**Status and implementation of the Agreement on the
International Carriage of Perishable Foodstuffs and
on the Special Equipment to be Used for such Carriage (ATP):
interpretation of ATP**

Explanatory document to ECE/TRANS/WP.11/2018/15

Transmitted by the Government of Finland

Proposed amendment to Annex 1, Appendix 2, Paragraph 6.5:

Unstable outside conditions, example data and figure:

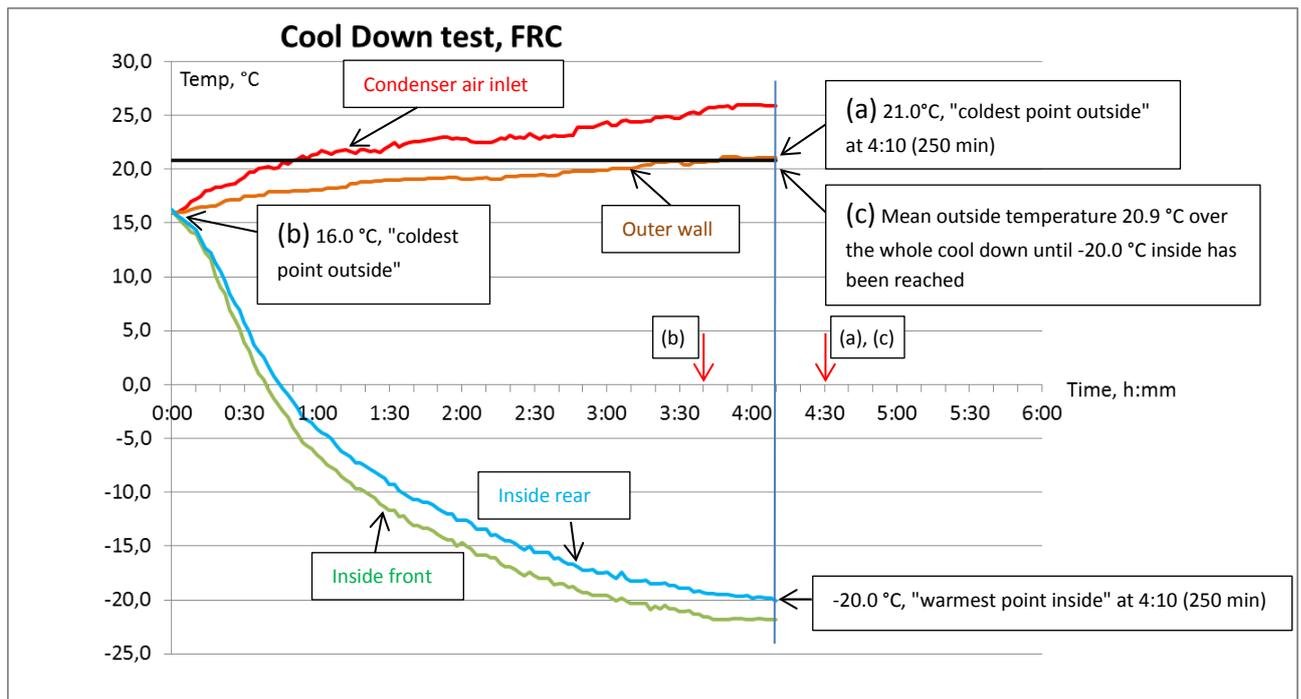
Cool down time from the initial temperature 16.0 °C to the class temperature -20.0 °C is 4:10 (250 min)

Three different interpretations:

- (a) "Coldest point outside" when class temperature has been reached, 21.0 °C → max cool down time 4:30 (270 min) → **PASS**
- (b) "Coldest point outside" over the whole cool down, 16.0 °C → max cool down time to 3:40 (220 min) → **FAIL**
- (c) Mean outside temperature over the whole cool down, 20.9 °C → max cool down time 4:30 (270 min) (note 20.9 is rounded to 21) → **PASS**

Depending on the interpretation, the result could be PASS or FAIL. For example in class FRC each degree of C represents 10 minutes in allowed cool down time.

Stable outside conditions, example data and figure:

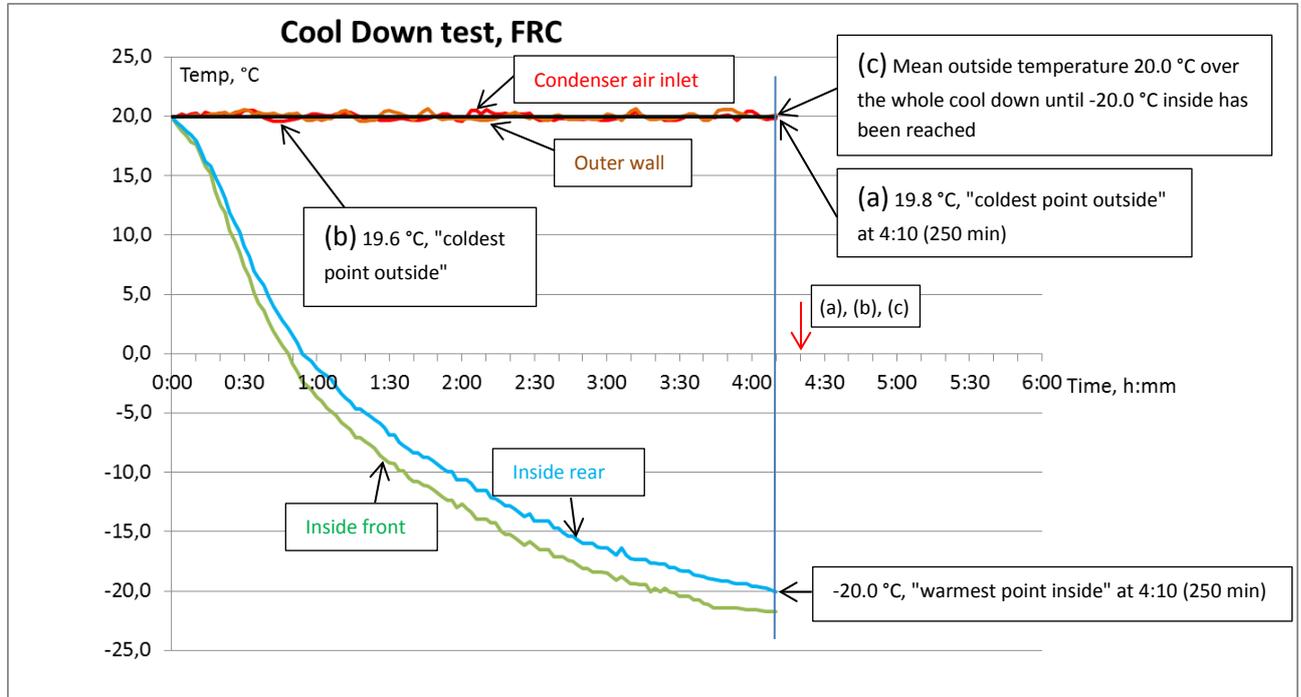
Cool down time from the initial temperature 20.0 °C to the class temperature -20.0 °C is 4:10 (250 min)

Three different interpretations:

- (a) "Coldest point outside" when class temperature has been reached, 19.8 °C → max cool down time 4:20 (260 min) (note 19.8 is rounded to 20) → **PASS**
- (b) "Coldest point outside" over the whole cool down, 19.6 °C → max cool down time to 4:20 (260 min) (note 19.6 is rounded to 20) → **PASS**
- (c) Mean outside temperature over the whole cool down, 20.0 °C → max cool down time 4:20 (260 min) → **PASS**

No remarkable differences between interpretations if outside temperature remains stable.
